RENESAS TECHNICAL UPDATE

Product Category	MPU/MCU		Document No.	TN-RZ*-A0082A/E	Rev.	1.00
Title	Initialization setting issue of CRU MIPI CSI2 Link Registers		Information Category	Technical Notification		
Applicable Product	RZ/G2L Group RZ/G2LC Group RZ/V2L Group	Lot No.	Reference Document	RZ/G2L Group, RZ/G2LC Group User's Manual: Hardware Rev.1.00 (R01UH0914EJ0100) RZ/V2L Group User's Manual: Hardware Rev.1.00 (R01UH0936EJ0100)		
		All lots

Additional operations are added to "35.3.1, Figure 35.33 Reception Start Flow for the MIPI CSI-2 Input" to avoid this issue.

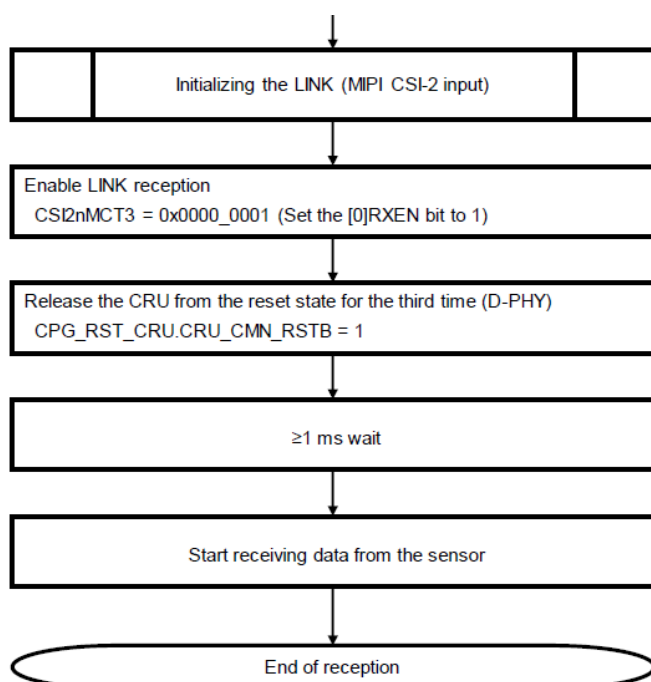
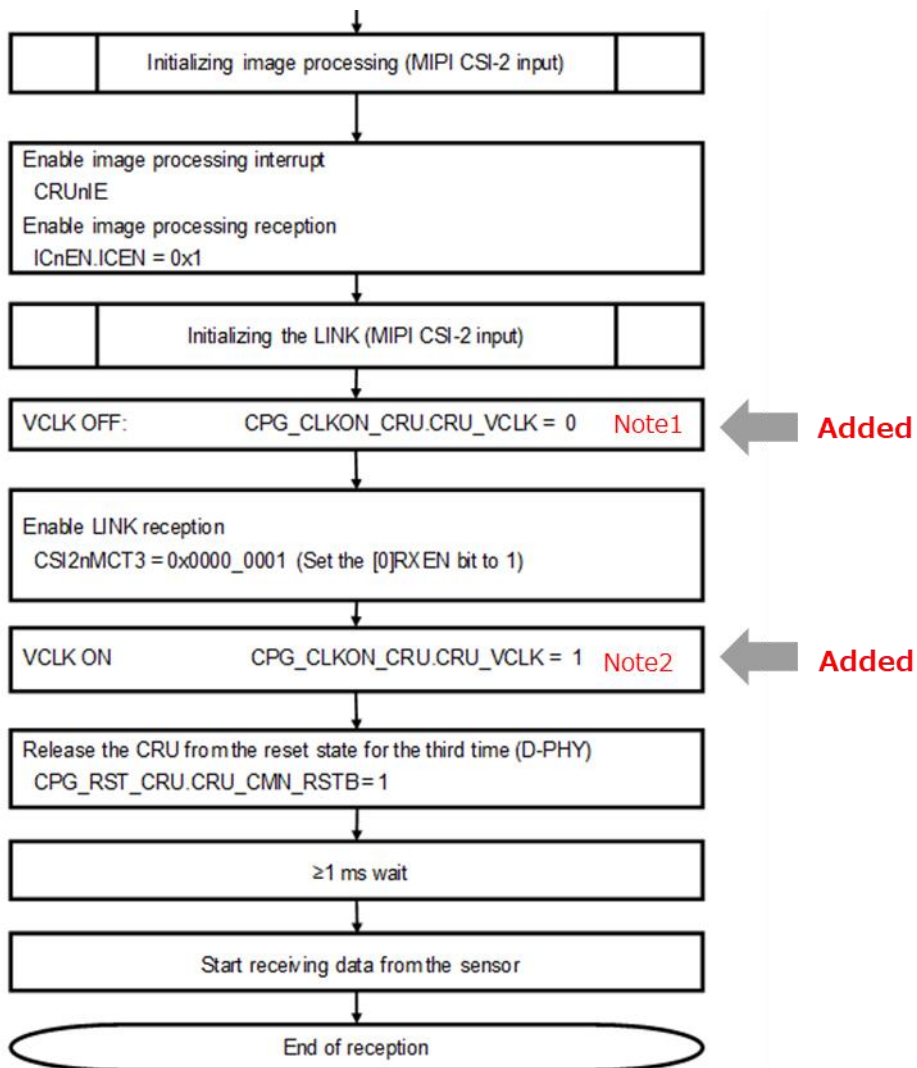
At the time of initial setting, the following MIPI-CSI2 Link register setting may not be reflected correctly.

Note1: After VCLK OFF setting, confirm whether VCLK is off by reading CPG_CLKMON_CRU.CLK1_ON=0.

Note2: After VCLK ON setting, confirm whether VCLK is on by reading CPG_CLKMON_CRU.CLK1_ON=1.
